# 1975 - 1982 Corvette: Service Bulletin: Viton Accelerator Pumps - Current and Past Models Equipped with Dual and Quadrajets

**Subject:** Viton Accelerator Pumps - Current and Past Models Equipped with Dual and Quadrajets

**Bulletin No:** 83-I-65

**Date:** May, 1983

FIGURE 1. (DUALJET SHOWN)

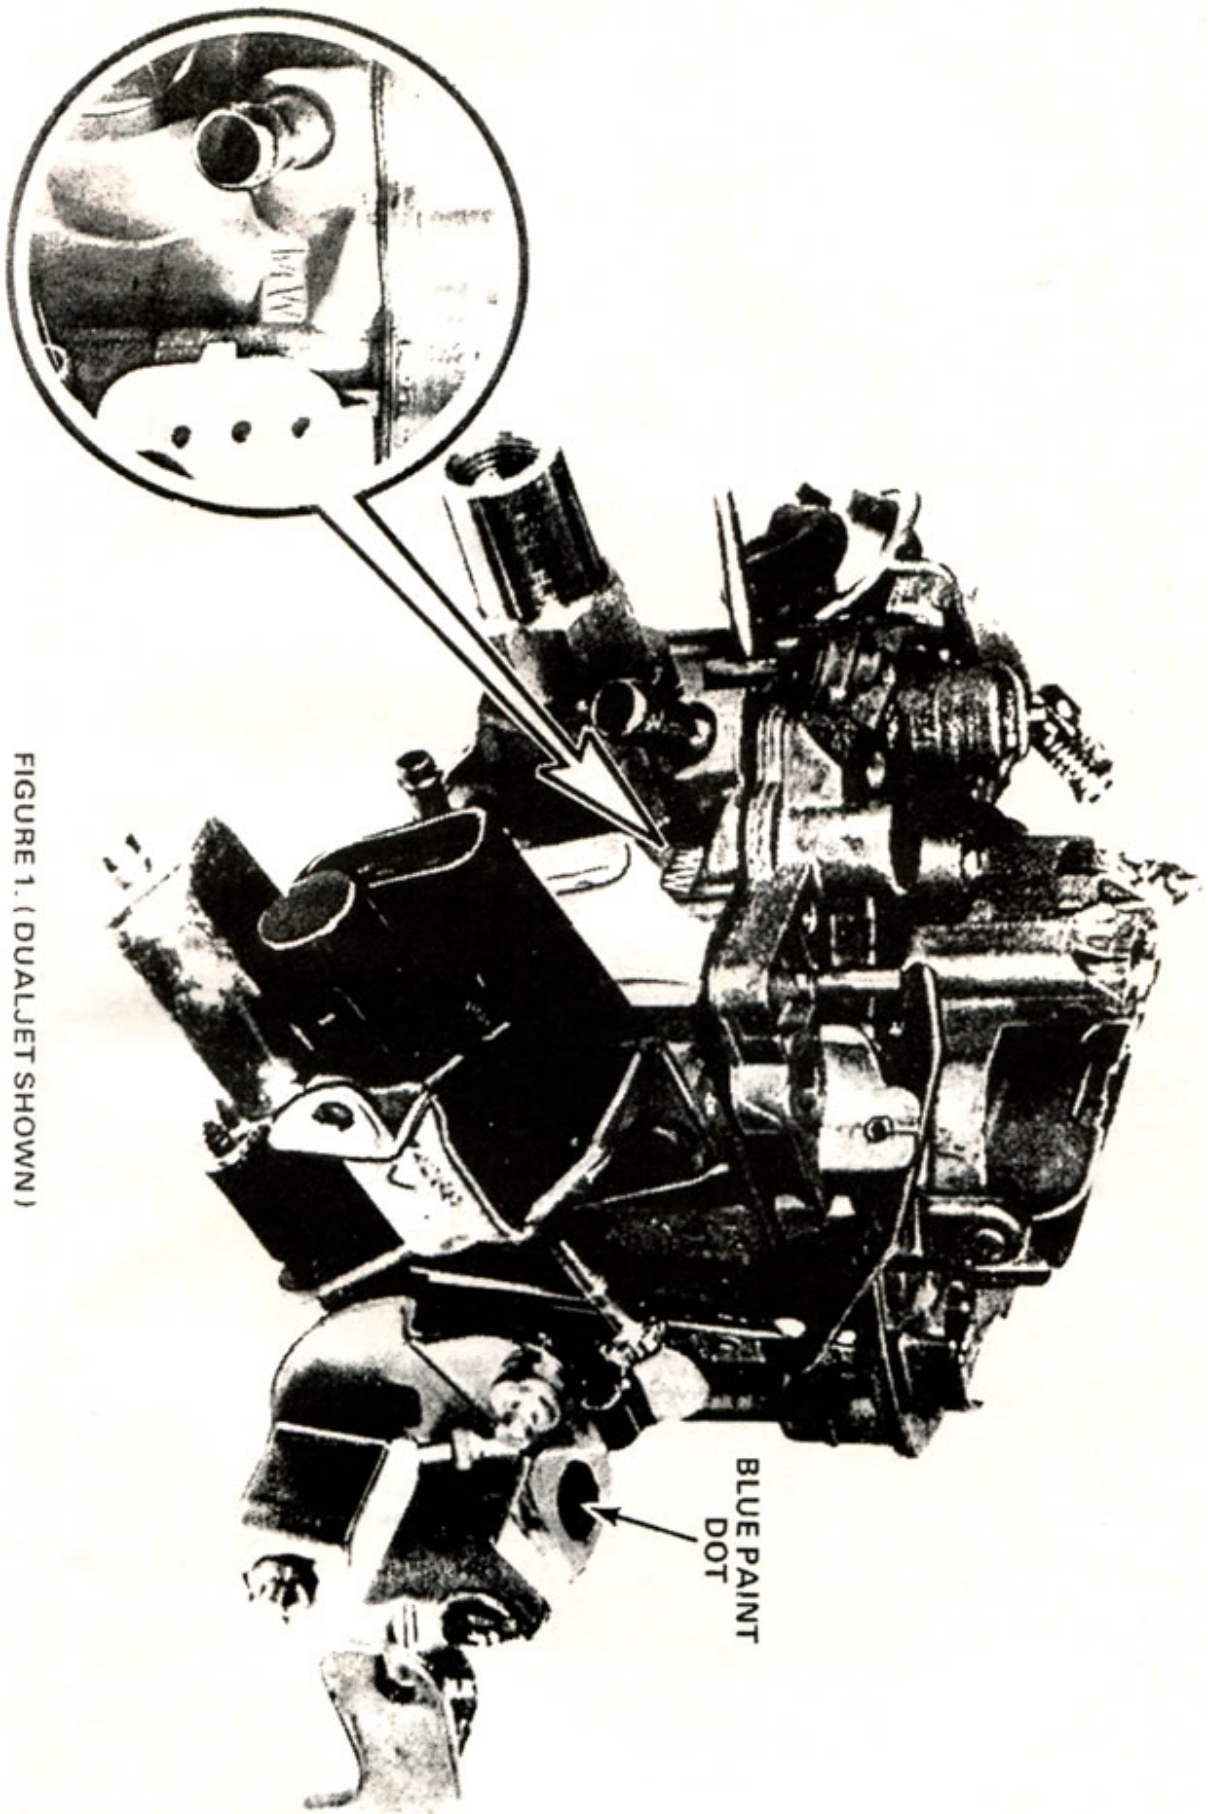
Float bowl assemblies that have the letters "MW" (machined well) embossed next to the throttle position sensor electrical connector use the red lip (with garter spring) viton accelerator pump only . See Figure 1.

Some 1982-83 "MW" flat bowl assemblies used during production were assembled with the red viton pump and some were not. if the float bowl

assembly does not contain the red viton pump, a blue dot will be on the rear of the throttle body near the bolt hole. See Figure 1.

PUMP ASSEMBLIES USED IN DUALJET AND QUADRAJET

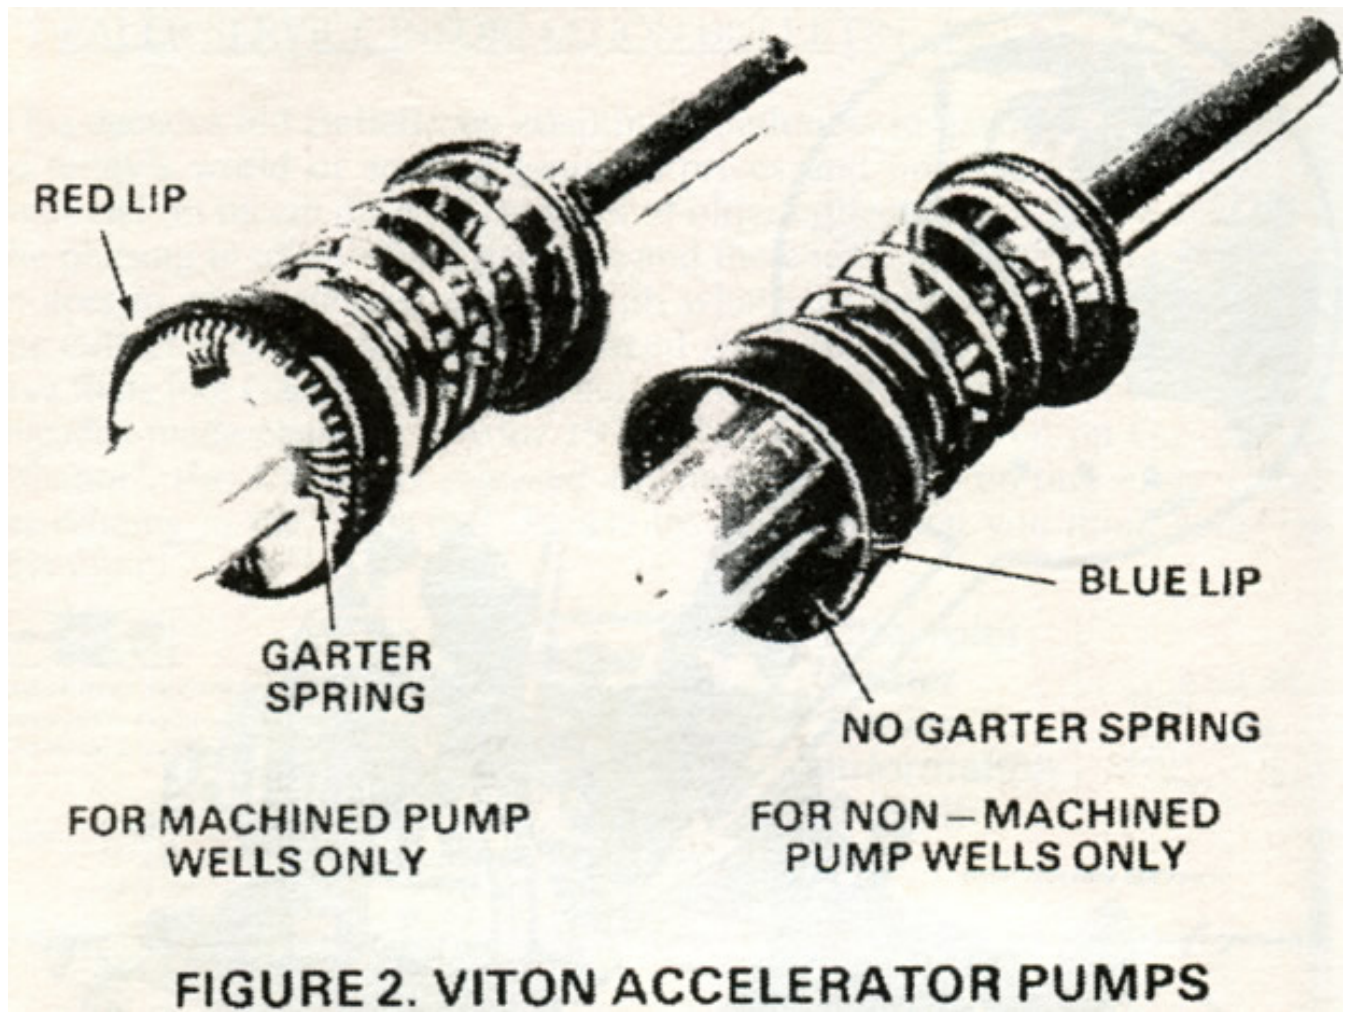
Viton service replacement pumps are identified as H.D. (Heavy Duty) in the parts book and are shown in Figure 2.
